Intel[®] StrongARM[®] SA-1110 Microprocessor

Specification Update

January 2000

Order Number: [278259-015](#)

10. Big and Little Endian DMA Transfers: Figure 11-2

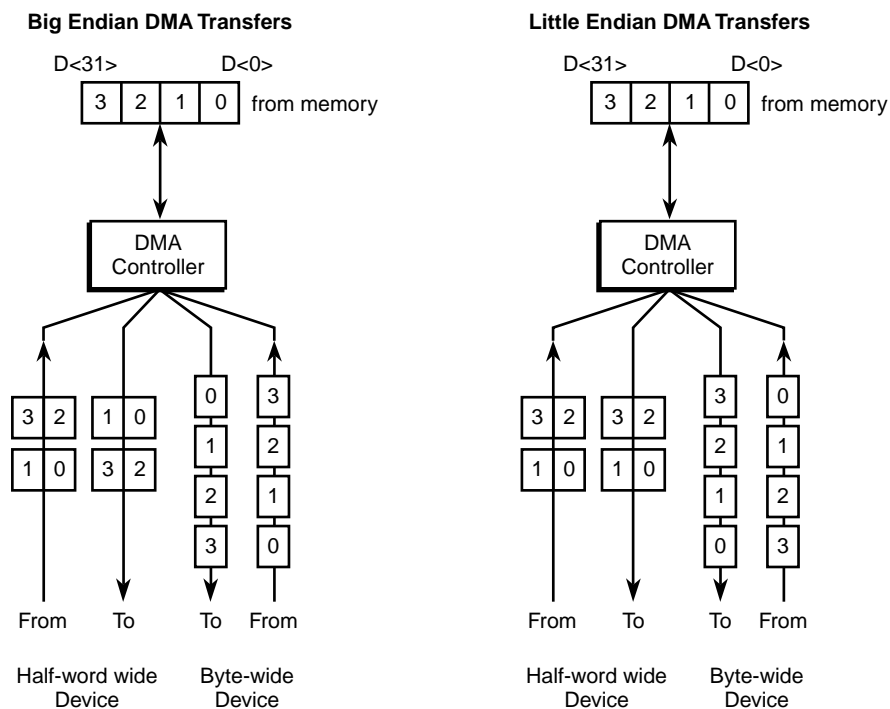
Figure 11-2 replaced with:

Figure 10-5: DRAM Single-Beat Transactions

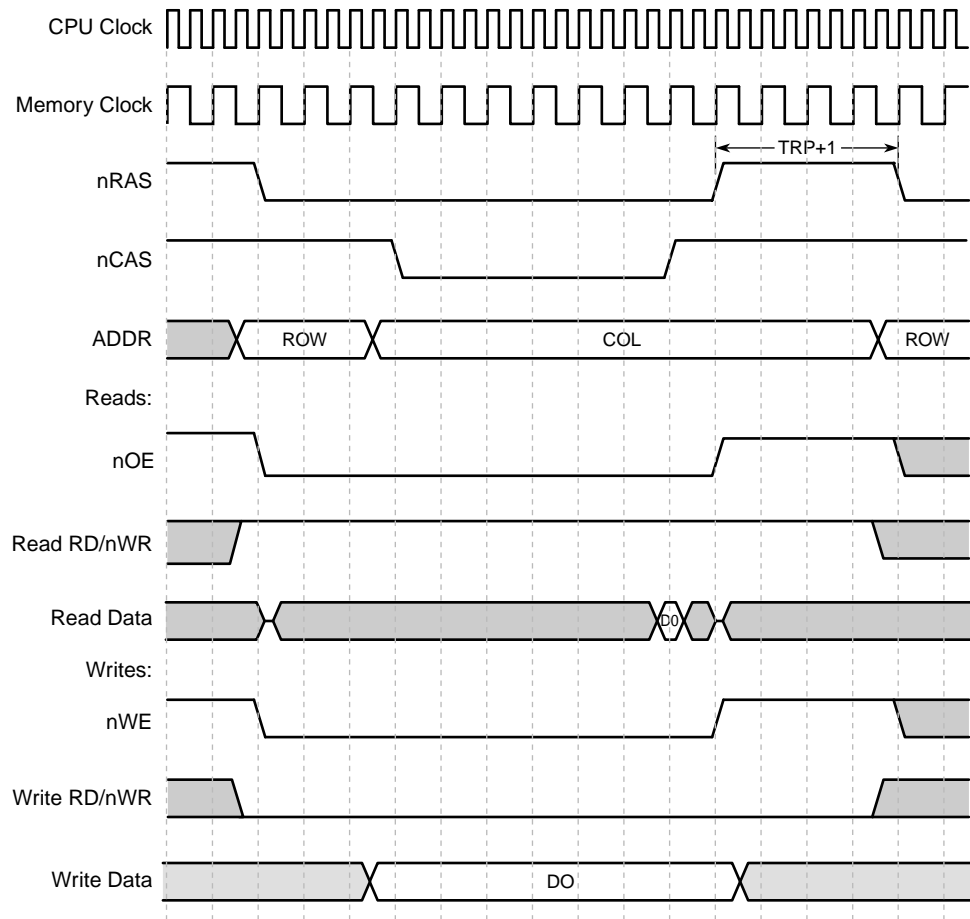
Design changes to the RD/nWR pin affected changes to the following timing diagrams:
